Designer Fashion Ltd. (Warehouse)

Buildings Information

1. Warehouse (Building No-2) (G+1)

Observations: Warehouse (Building No-2)

Live load plan- Mezzanine floor (above ground)

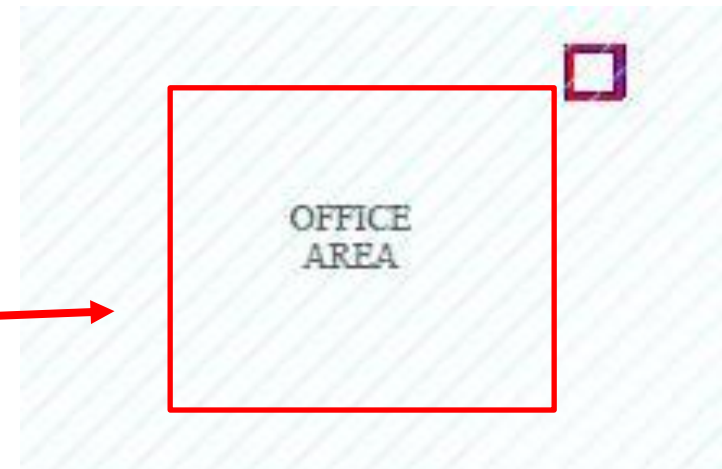
Prepared load plan to be revised

Office area mentioned in the load plan with live load limit of 5 kPa.

Storage on Mezzanine above ground floor.

Live load on mezzanine floor above ground is considered as 5 kPa in prepared load plan and occupancy type shown as office but storage was observed on that area. As per BNBC- Part 6, live load for light storage areas is required to be considered minimum 6 kPa. However, the building engineer is required to revise the live load plan as per BNBC requirement and check the design accordingly.

Stressed foundation in layout (yellow mark)

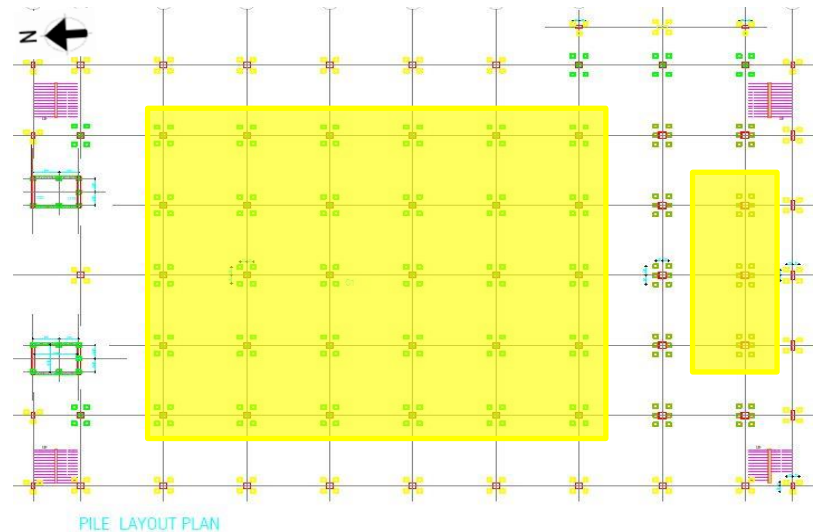
**Foundation stress exceeds normal design limit for
proposed 4 storied building**

For proposed 4 storied building, the cursory calculation indicates that factor of safety (FoS) of internal pile foundations is below the allowable limit. The building engineer is required to carryout a Detail Engineering Assessment (DEA) and submit to the RSC prior for review prior to conduct any further extension above existing 2 storied building.

Present roof layout

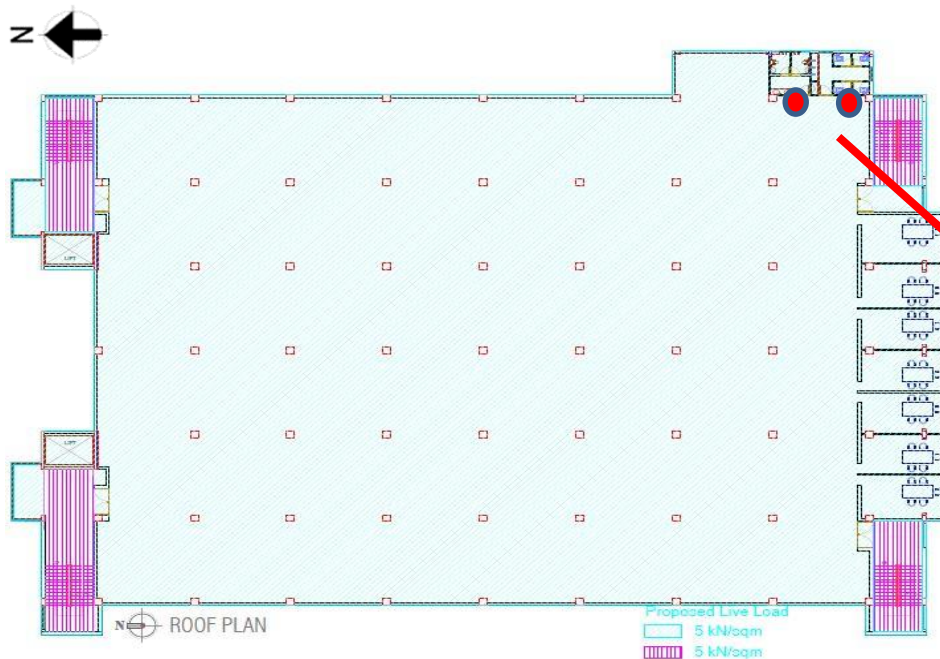
Discrepancy in as-built drawing

Two plastic water tanks (capacity- 2000 litre each) found on roof slab which were not shown in roof layout. The building engineer is required to update the current roof layout plan.

Layout of steel roofing on staircases

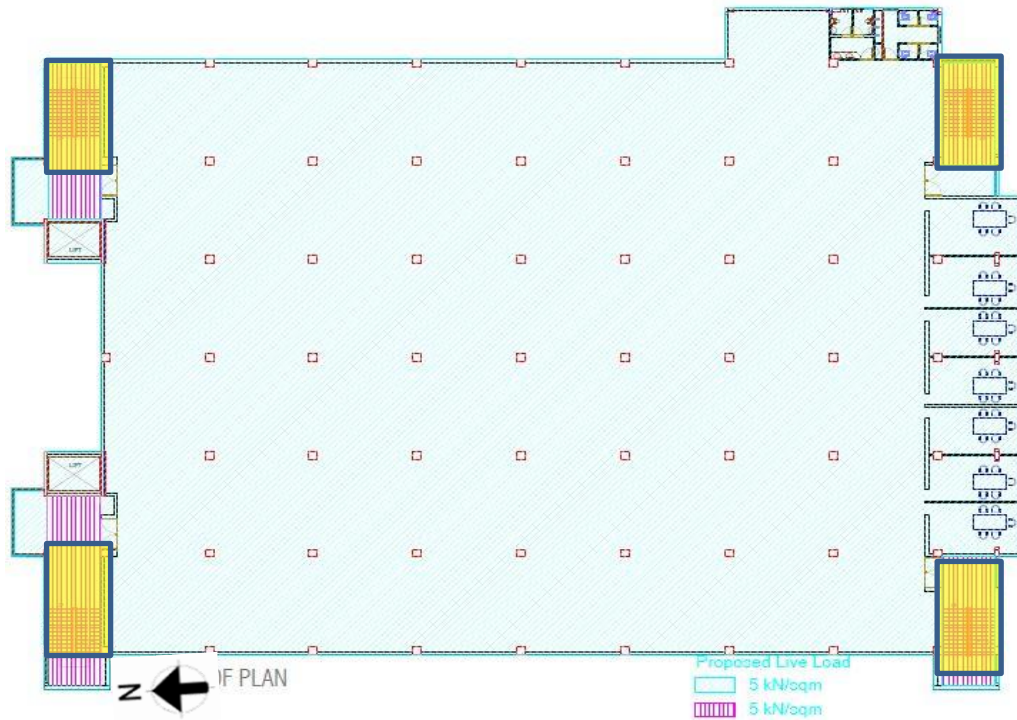
Apparently inadequate connection

Roof truss not anchored with the rebar of RC column

Connections of truss to RC column at roof of staircases were appeared to be inadequate for uplift forces. The building engineer is required to check the connections for uplift forces and suggest proper remedial actions accordingly.
